# Groundwater Application Review Summary Form

Application # G- 19456

GW Reviewer Gabriela Ferreira Date Review Completed: December 13, 2024

# PUBLIC INTEREST REVIEW FOR GROUNDWATER APPLICATIONS

**Application G-19456 Cristian Strava**  
**T3S, R1E, Section 25**

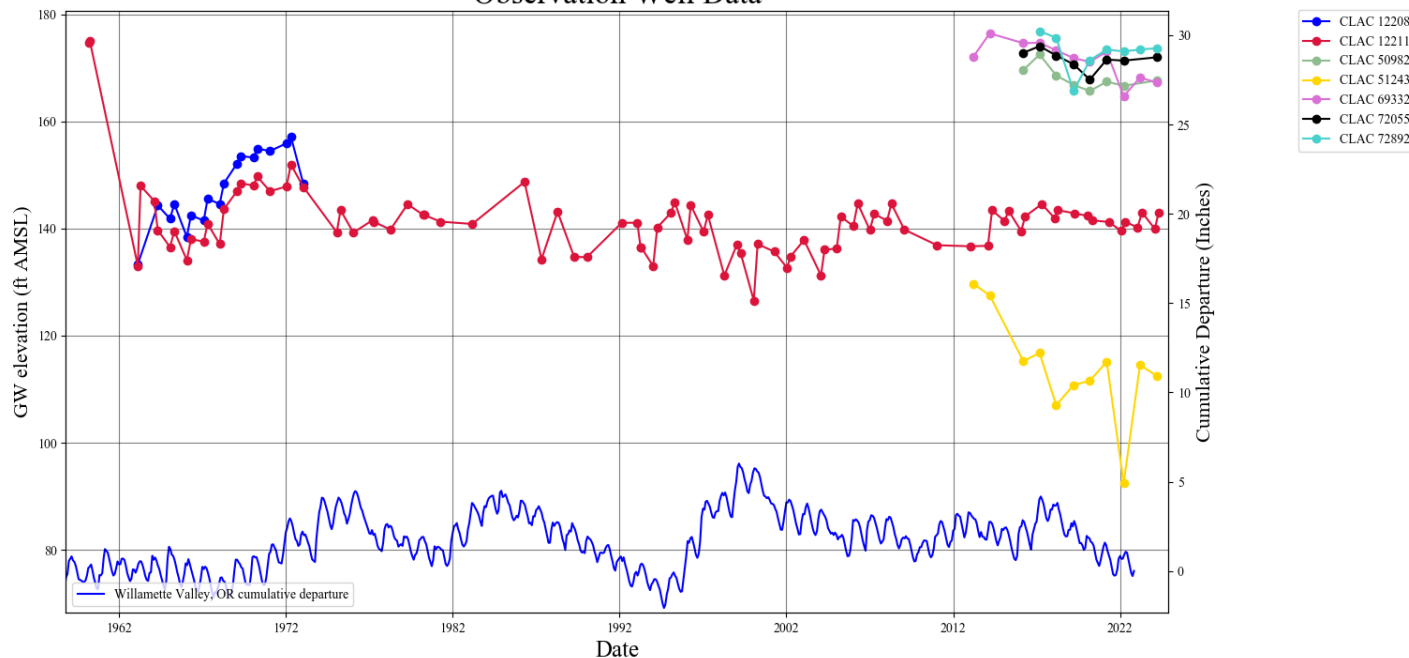
A4. **Comments:** The proposed POA/POU is approximately 3 miles northwest of Molalla. Applicant proposes irrigation use on 41.8 acres by one well already constructed (CLAC 12433) and one well to be constructed.

## Modeled Interference with proposed Well 2 (App G-19229) from pumping proposed Well 2 (App G-19456)

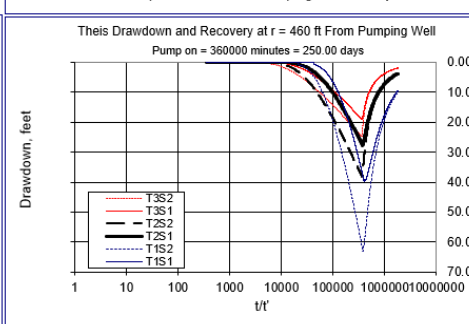
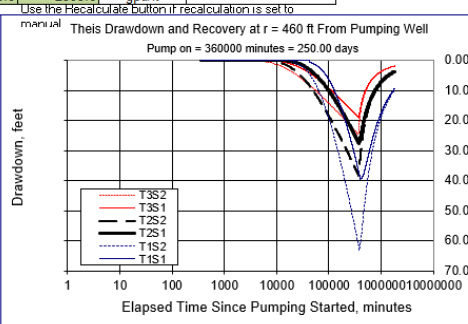
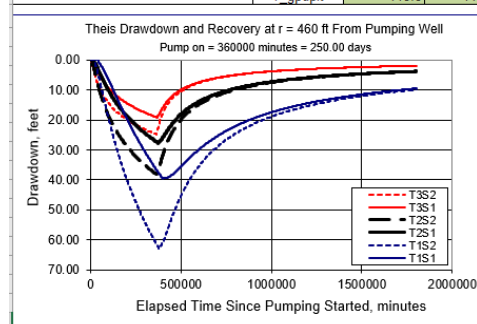
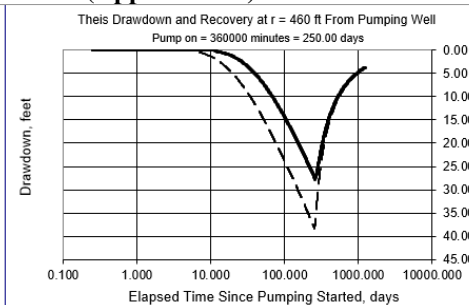
The nearest groundwater user was identified as proposed Well 2 under Application G-19229, located approximately 460 feet northwest of the proposed POA 2. Despite not being complete or approved as a POA, nor fully penetrating the alluvial aquifer system, potential impacts on the proposed well were modeled using the attached Theis drawdown analysis and assuming the full duty and rate of the proposed POA. Transmissivity values are based on pump tests from nearby alluvial wells. It appears unlikely that interference would produce drawdown at the proposed well in excess of the typical permit condition limits
